From: Reed, Tim
Sent: Tuesday, April 13, 2021 11:06 AM
To: MAUER, Andrew
Cc: ANDERSON, Victoria; Lingam, Siva; Kichline, Michelle; McKenna, Philip; Dixon-Herrity, Jennifer; Zoulis, Antonios; Bowman, Greg
Subject: RE: RE: Draft NEI RIPE Guidance
Attachments: DRAFT NEI 21-01 with NRC Comments -provided to NEI on 4-13-2021.docx

Attached please find our comments on your draft NEI Guidance document NEI-21-01, "Industry Guidance to Support Implementation of NRC's Risk-Informed Process for Evaluations," transmitted to us by your email on March 22, 2021 (ADAMS Accession No. ML21085A026). The comments provided are those of the RIPE working group and do not represent an official NRC position.

Industry Guidance to Support Implementation of NRC's Risk-Informed Process for Evaluations

Figure 1-1: RIPE Applicability Flowchart

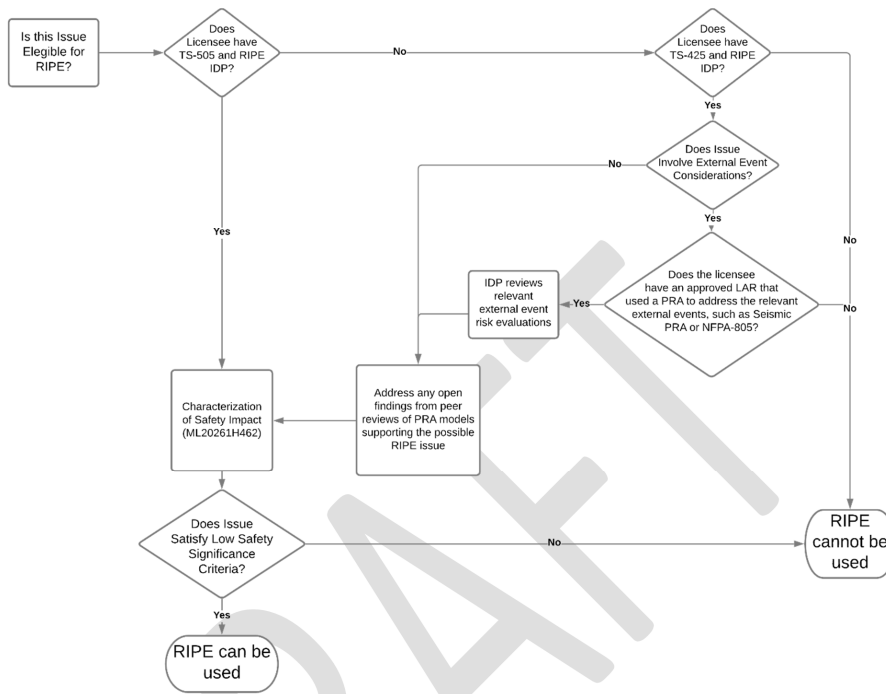
Commented [A2]: Add reference for this.

Commented [A3]: Expand guidance on how licensees should do this assessment. In addition, licensees relying on TSTF-425 must also include a discussion of how they have maintained their PRAs up to date.

Figure 4-1: Safety Impact Characterization Detailed Process Overview

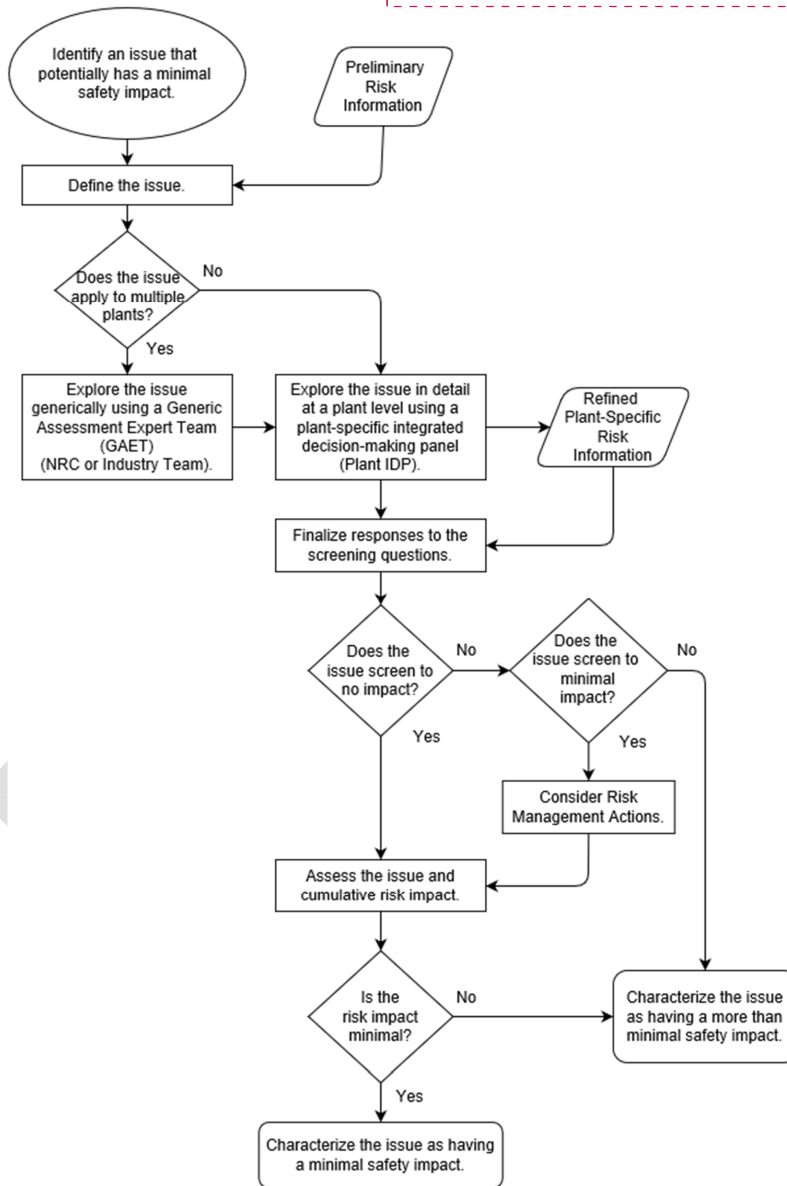
Commented [A13]: Remove reference to NRC participation in GAET.
